Subject: #PP18-00003- Development at 345 & 375 Mine Hill Rd SW - Statement of Opposition **Attachments:** 2019-0404-Development at 345 and 375 Mine Hill Rd SW-Statement of Opposition.pdf

Mine Hill Creek – Subdivision

VAR20-00001

Subject: Mine Hill Creek Subdivision

Attachment: Mine Hill Site Map, notated

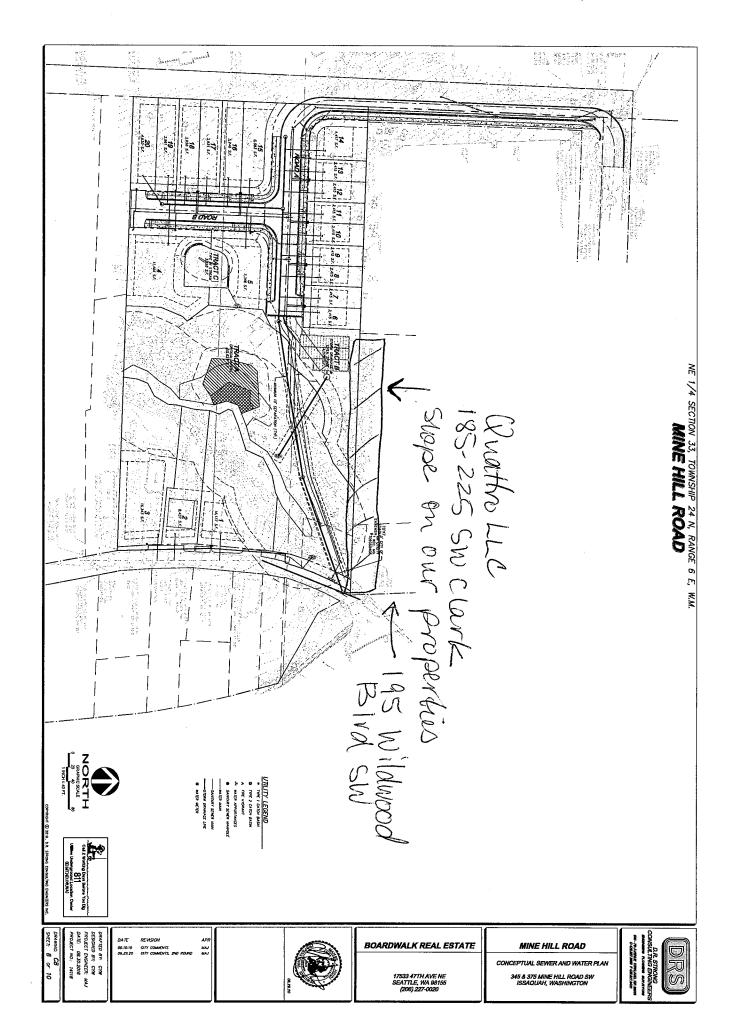
We own the property which is immediately north of the eastern half of the proposed subdivision. Our property includes a 30-unit apartment complex at 185-225 SW Clark and, in the easterly adjacent lot, a fourplex at 195 Wildwood Boulevard SW. These properties are on the downhill slope from the Mine Hill Creek Subdivision property. For this reason, the requested variance regarding drainage in this location and entire project is problematic and worrisome.

Our larger property includes a building of eight apartment units that runs parallel to the Mine Hill Creek property line and a building of six units which is perpendicular to the Mine Hill Creek plat. The fourplex is situated at the lowest end of the proposed runoff and water and utilities lines. Drainage in this area (highlighted area on the attached site map) has been an ongoing problem during the entire duration of our ownership beginning in 1999 to the present. Runoff from the Mine Hill Creek side of the hill results in a constantly damp and soggy ground. We have needed to install additional drainage basins in this area to address the runoff. Please note this has been required before any construction on the uphill property was even proposed. In addition, there are numerous mature trees and vegetation along this property line. Over the years, trees have fallen due to the soft, damp ground and damaged fences on the larger property and the dumpster surround on the fourplex property.

The current request for a variance has no information about any consideration of or studies about the impacts of surface and subterranean water outflows on these buildings or the large trees, all of which could be comprised. What is the anticipated amount of increased water runoff? Has this even been studied? What steps are being taken on the Mine Hill site to prevent negative impacts on neighboring properties? Will the city require studies to ensure that neighboring properties are not impacted? What steps will be taken to ensure that the lowest end of these outflows will not back up or otherwise undermine the neighboring properties?

We respectfully request that the City require the impacts of the stormwater outfalls and water and sewer utilities be fully studied for geotechnical issues and water runoff risks and diversions to ensure that the increased outflows and usages will not negatively impact our properties. In addition, the issuance of any variance should require completion of any remediation measures as suggested by the required studies.
